**IEC 60061-1**  
Amendment 58 to edition 3.0 2018-08

LAMP CAPS AND HOLDERS TOGETHER WITH  
GAUGES FOR THE CONTROL OF  
INTERCHANGEABILITY AND SAFETY –

Part 1: Lamp caps

## CORRIGENDUM 1

#### Figure 2

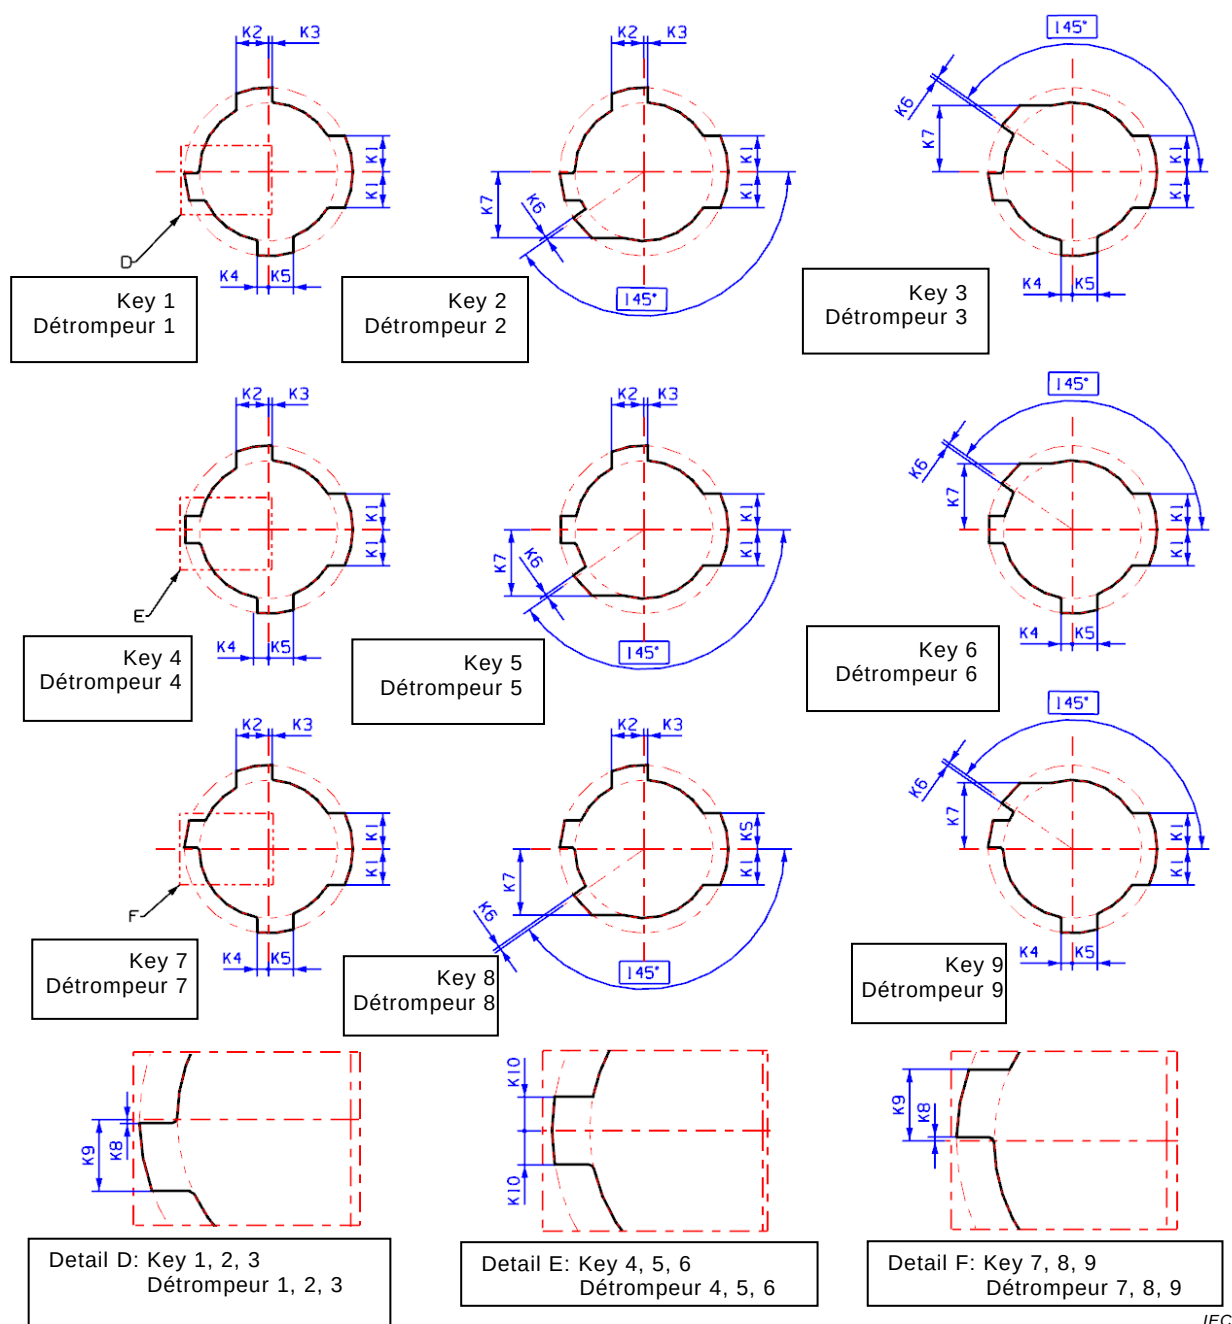
*Replace Figure 2 with the following new Figure 2 (addition of dimension K9 in Detail D: Key 1, 2, 3, Détrompeur 1, 2, 3):*
